MEMORANDUM

TO: Eluid L. Martinez, State Engineer

FROM: Tom Morrison, Peggy Barroll, & Andy Core, Hydrology
Section *TM* *P.B.* *AC*

SUBJECT: Proposed Saline Injection into the Capitan aquifer,
Lea County, New Mexico

Figure 1. Highly diagrammatic north-south stratigraphic section showing the positions and relationships of the major lithofacies in the rocks of Guadalupian age, eastern New Mexico.

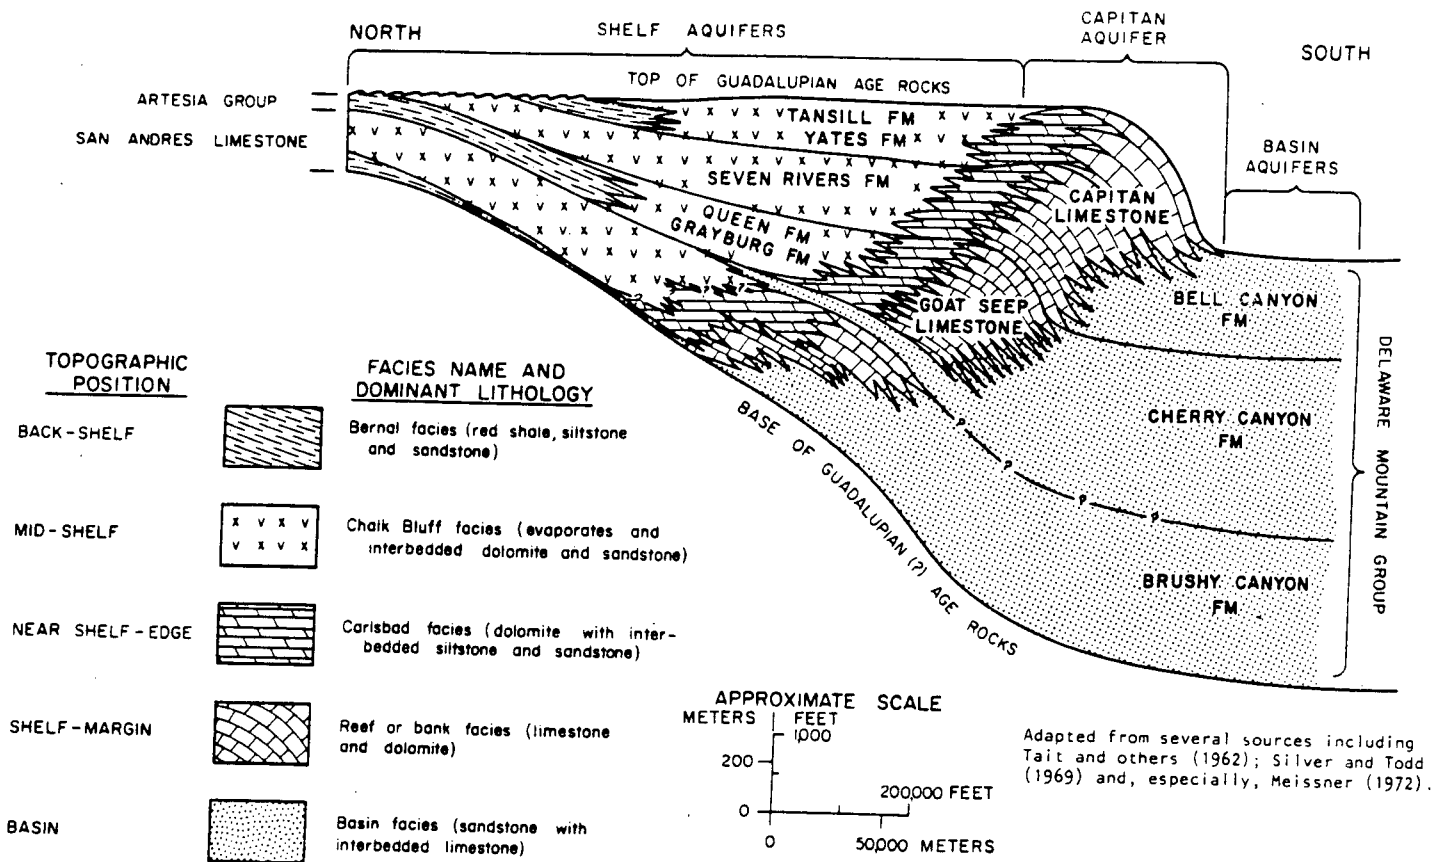
The Capitan aquifer (often referred to as the reef aquifer) is hosted by the Permian Capitan and Goat Seep Limestones and most of the Carlsbad facies of Meissner (Hiss, 1980). Hiss has divided the Permian facies of Guadalupian age into three aquifer groups (shelf, reef, and basin) as shown in Figure 1. The point of the three-fold division is to emphasize the very large contrasts in transmissivity (T) and salinity between the groups. East of the Pecos River, the Capitan aquifer is confined and the T is one to two orders of magnitude greater than either the shelf aquifers or the basin aquifers which surround it. Much of this increased T is probably due to solution cavities and fractures within the reef facies (Hiss, 1980). In essence, the Capitan may

Figure 2

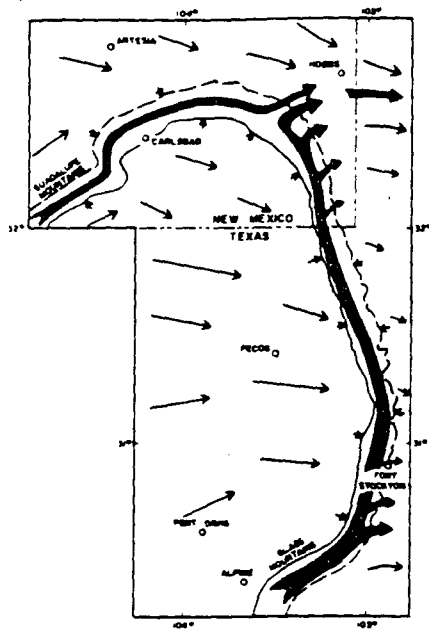
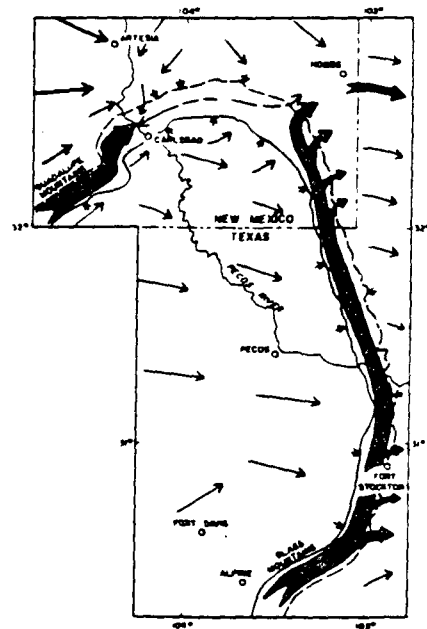
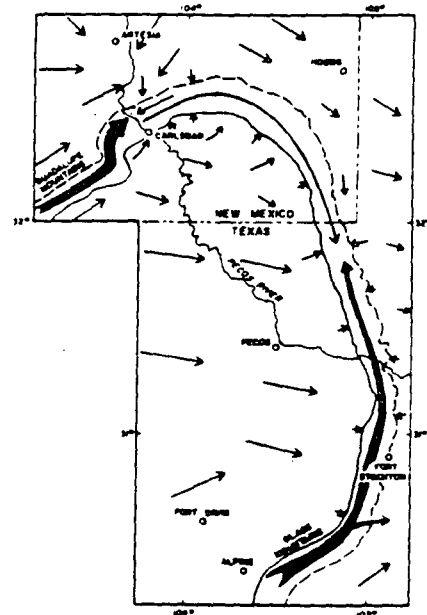
be visualized as a curved tube dipping to the east-northeast, carrying water from the surface in the Guadalupe Mountains of New Mexico and the Glass Mountains of Texas down into the subsurface near Hobbs. Figure 2 shows the changes in the flow of water through the Capitan aquifer, first as the Pecos River came into hydrologic connection with it, and then as the exploitation of water and oil resources impacted it.

Figure 4

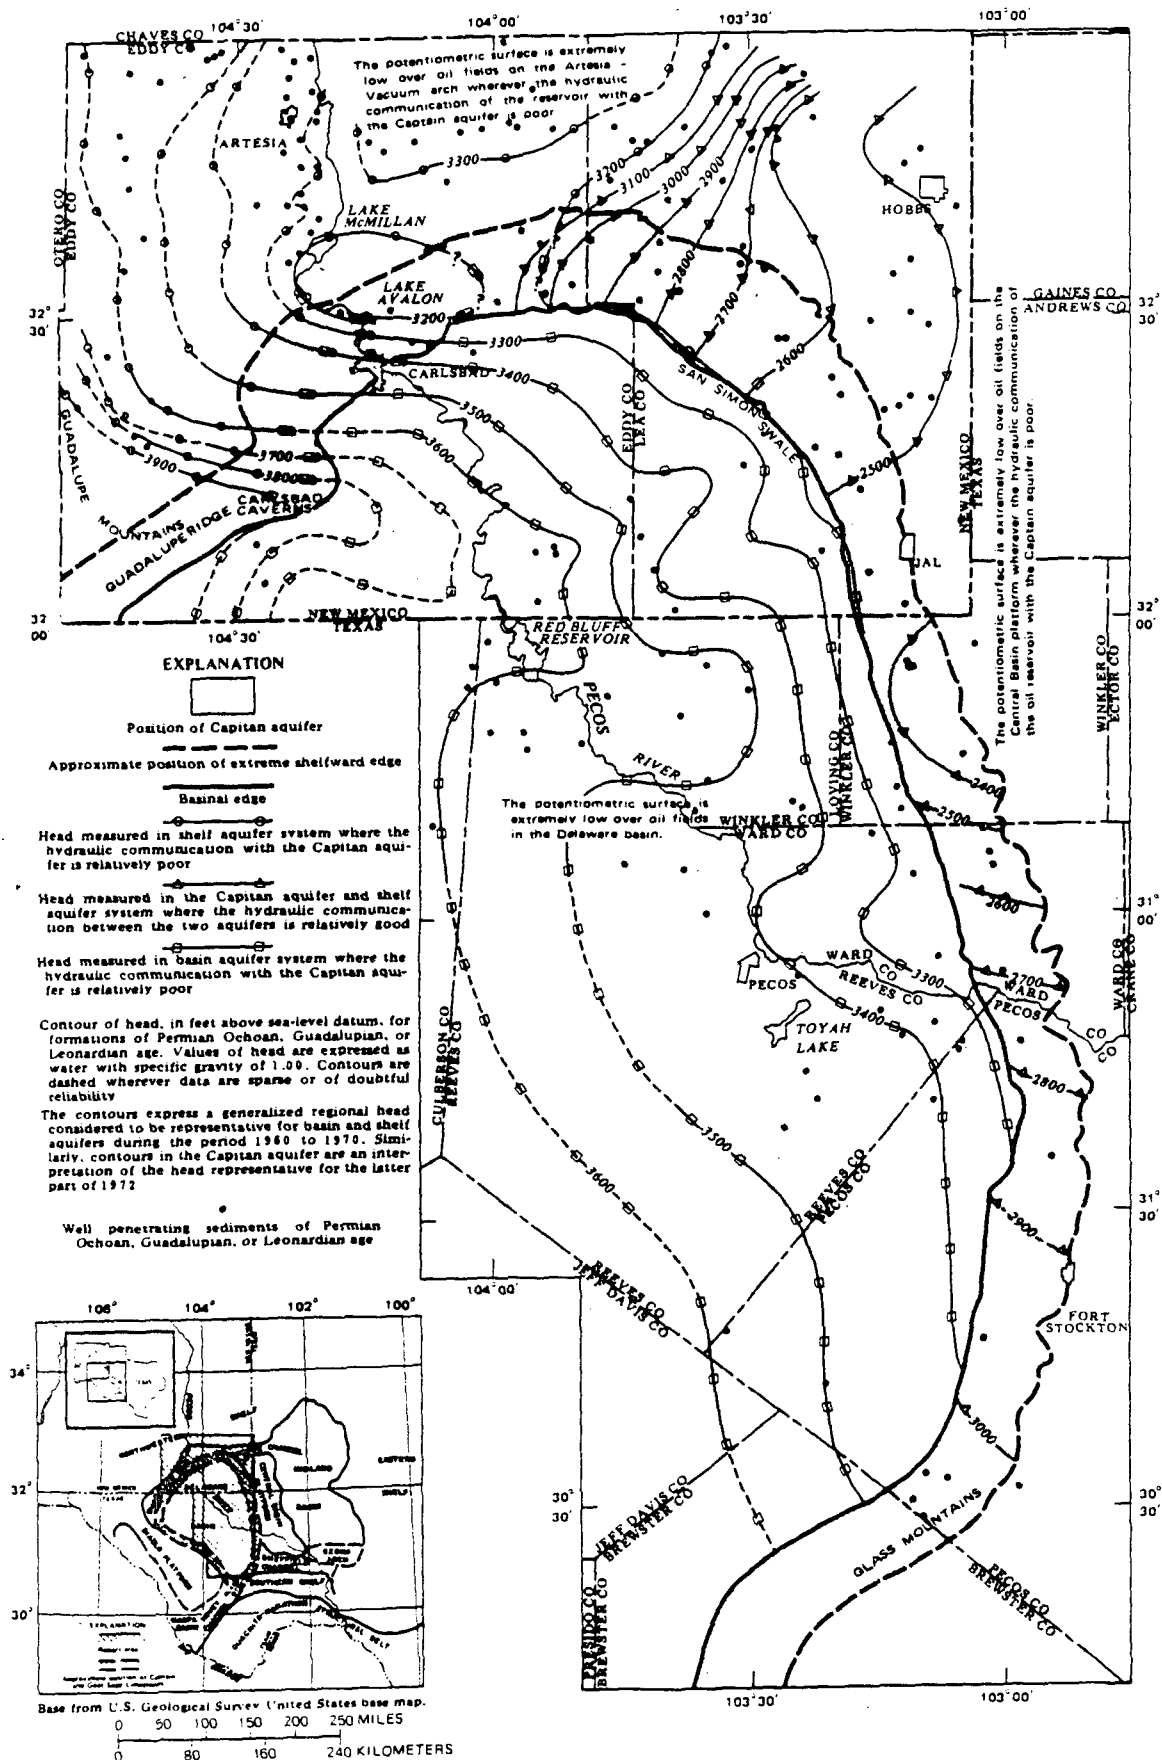
With minor exceptions in the northeast portion of the reef, the salinity of the waters contained in the shelf and basin aquifers are one to two orders of magnitude greater than that within the Capitan aquifer (Hiss, 1975). The reason for this appears to be the higher T which allows rapid movement of fresh water through the Capitan which dilutes the salt content within that aquifer. One implication of Figure 2 is that the salinity of the north-central part of the aquifer has risen over time as the volume of fresh water reaching that portion of the aquifer has diminished. Figure 3, which was published by the NMBMMR as resource map 4, shows the zones of fresh water in yellow, as indicated by chloride values of less than or equal to 5000 ppm. In preparing the figure the assumption was made that chloride content accounts for 50% of TDS in solution, which is the same assumption made by the consultant in his report. Also shown are the Pecos River and the location of the proposed injection well.
